Section 34 Agreement

351-53 New South Head Rd

Ground Floor Plan

West Elevation
Scale: 1:200

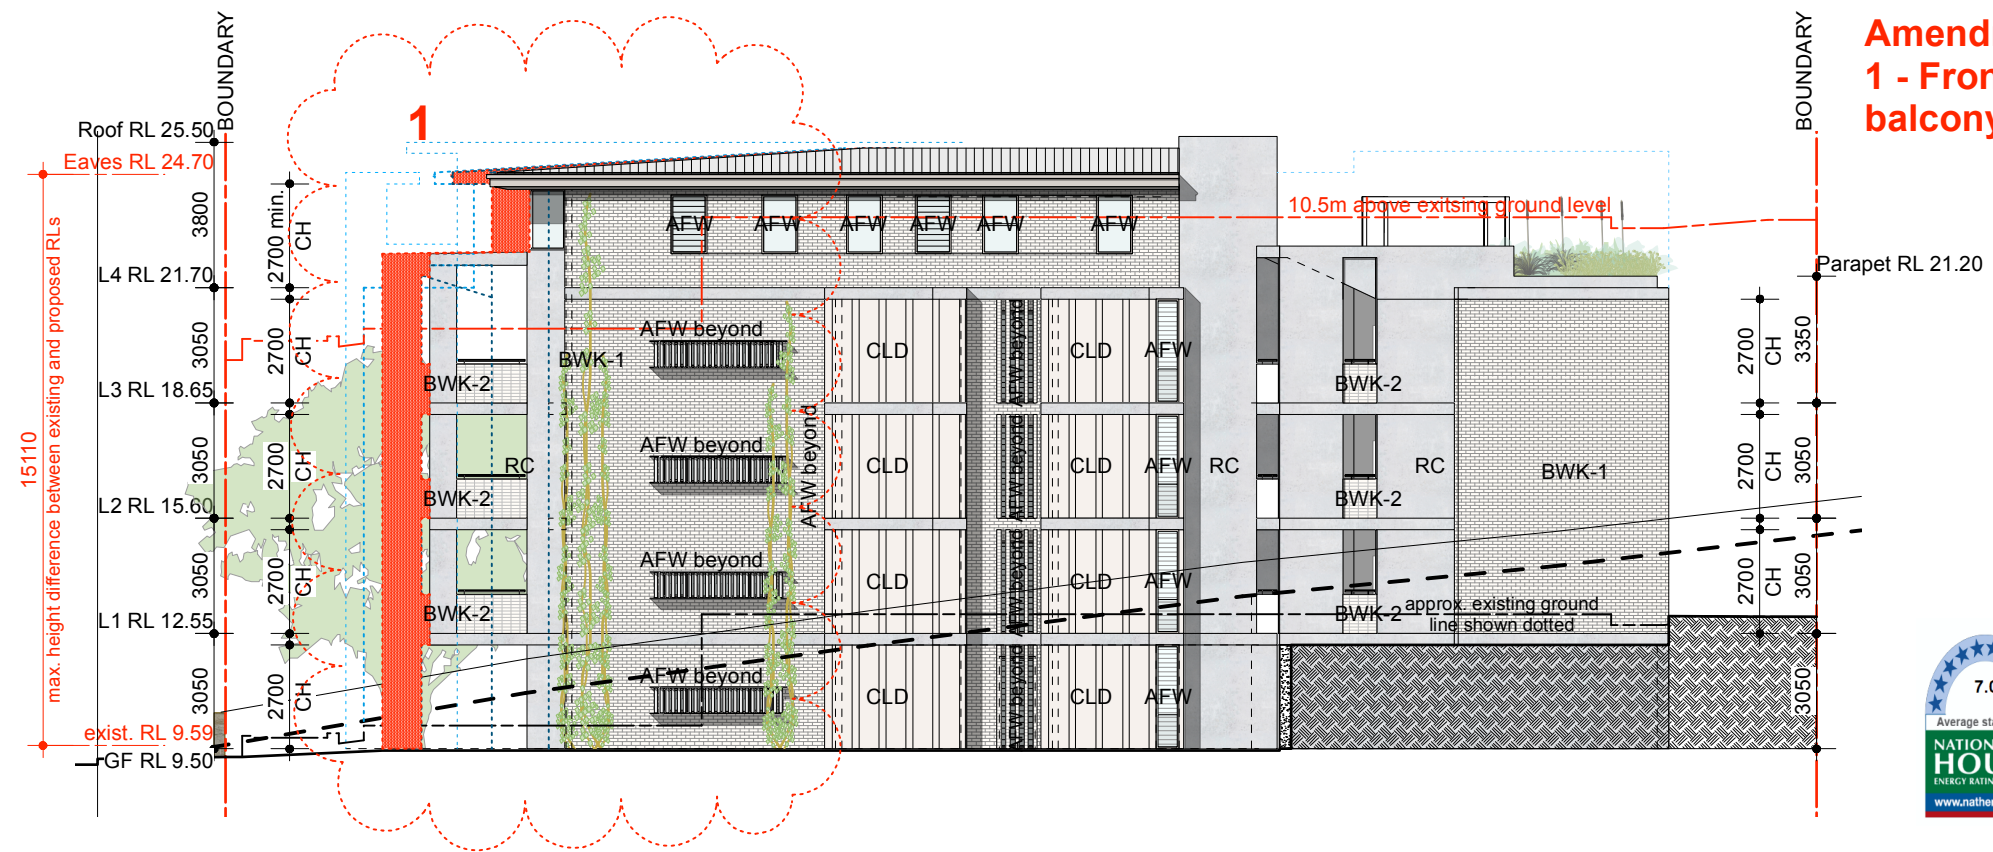
Amendments:
1 - Front setback increased,
balcony depth decreased

DRAWING TITLE			
DETAILED ELEVATION			
JOB NO	DRAWN	SCALE	DRAWING NO.
18.41	AR/BD	1:50 @ A3	DA 2.203
DATE	CHECKED	PLOT DATE	REVISION
Sept. 18	PT	14/7/21	G

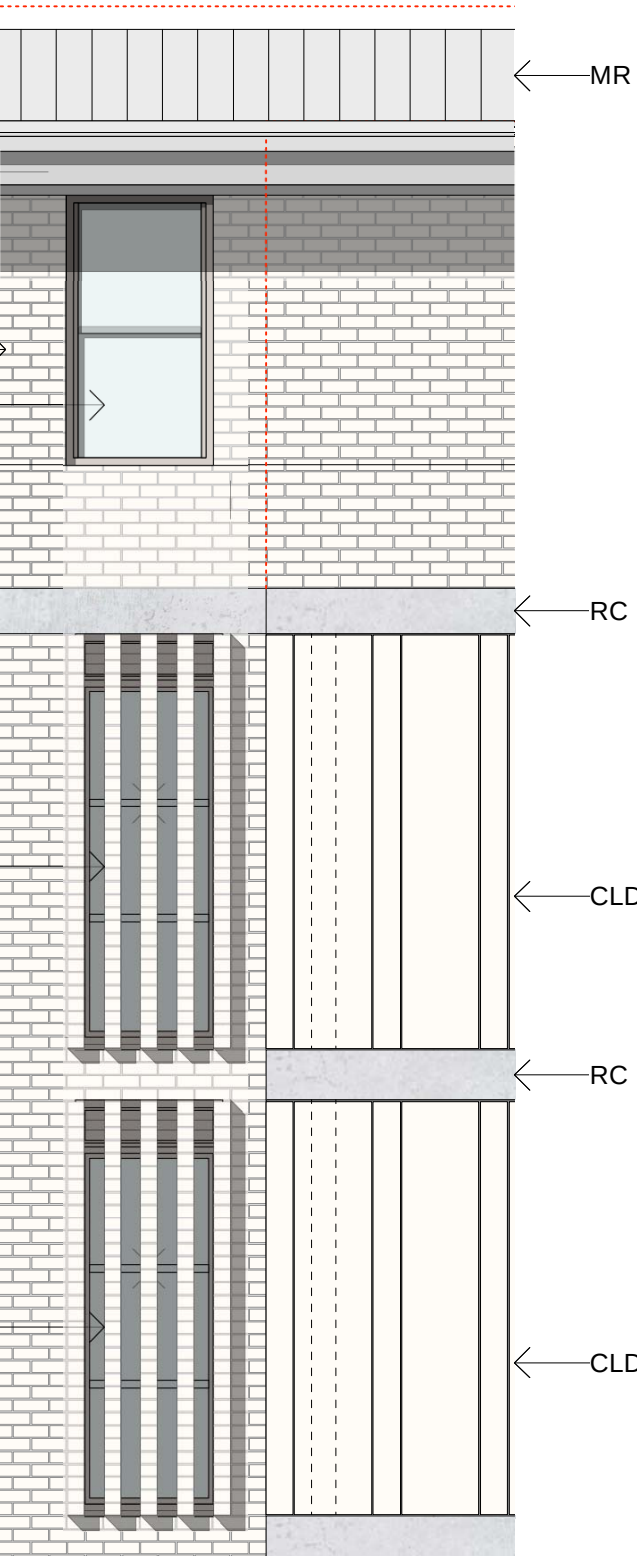
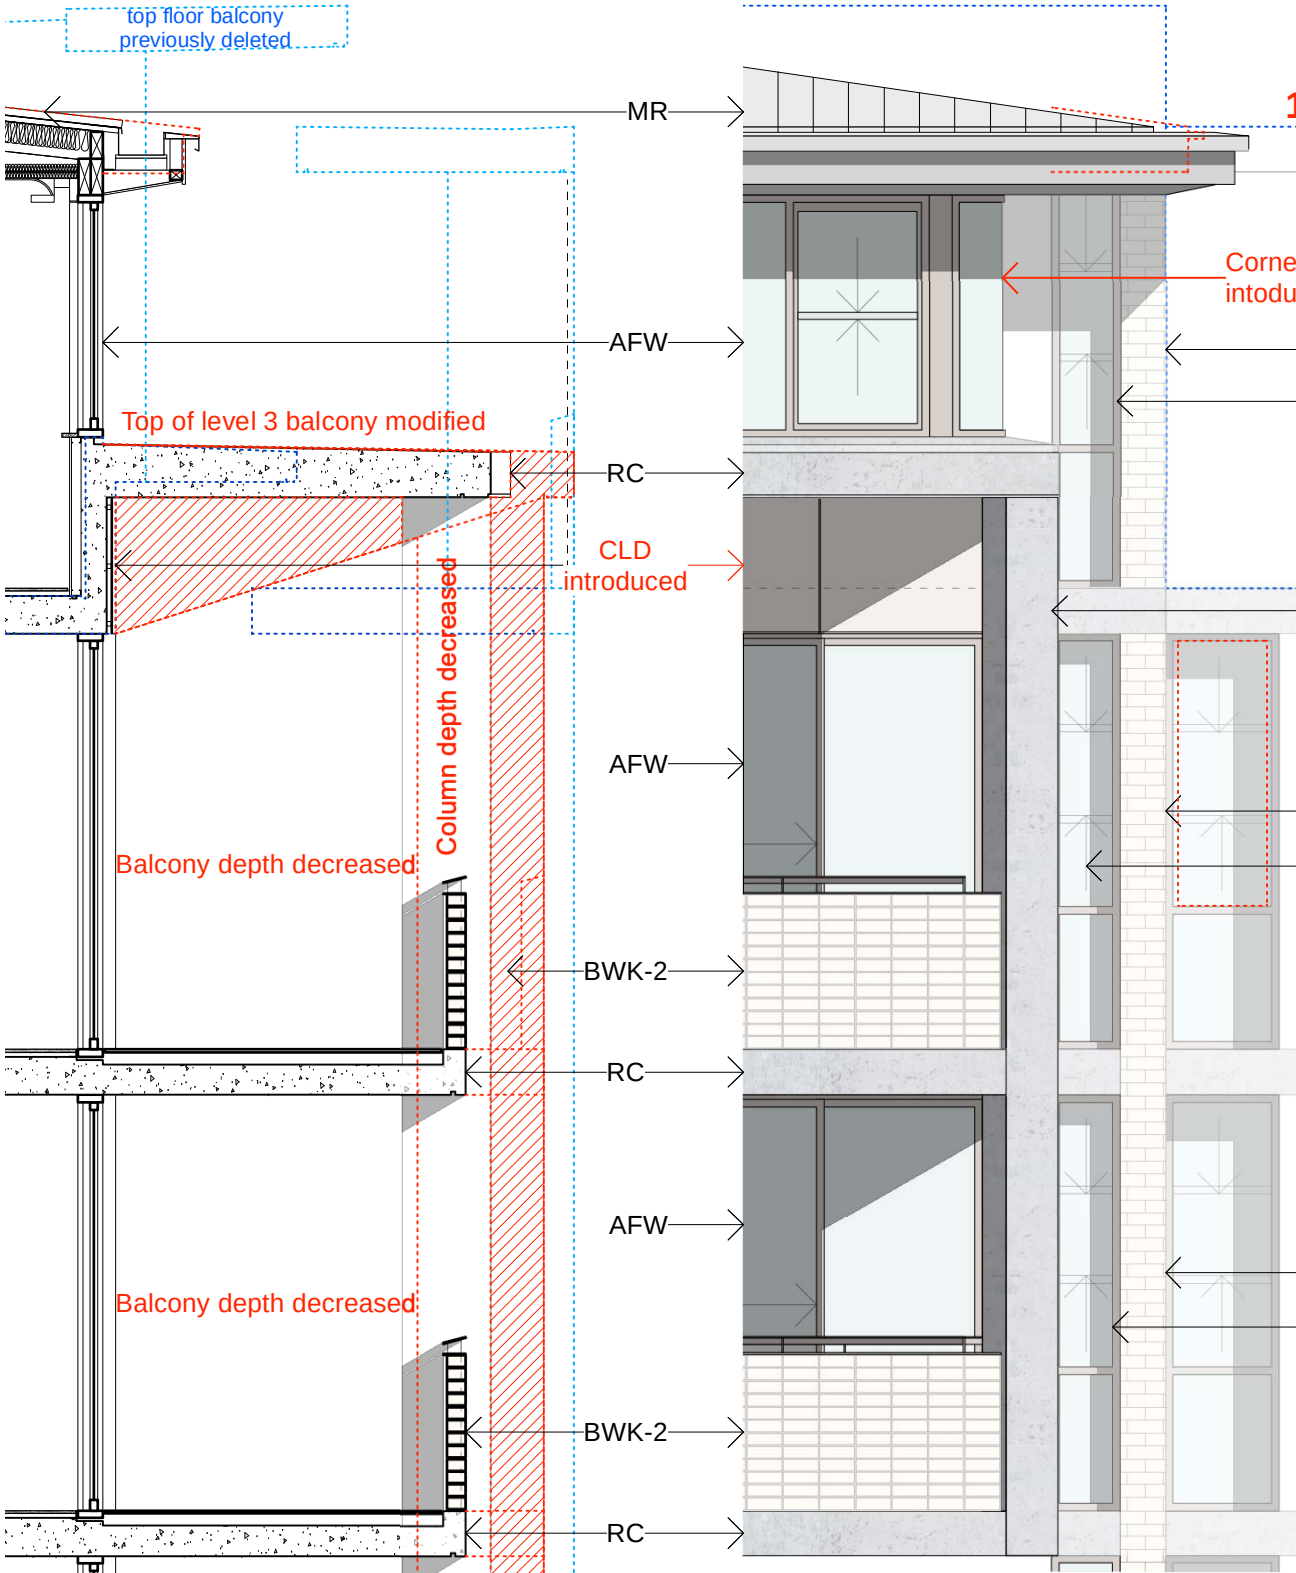
Amendments:
Section and Elevation modified
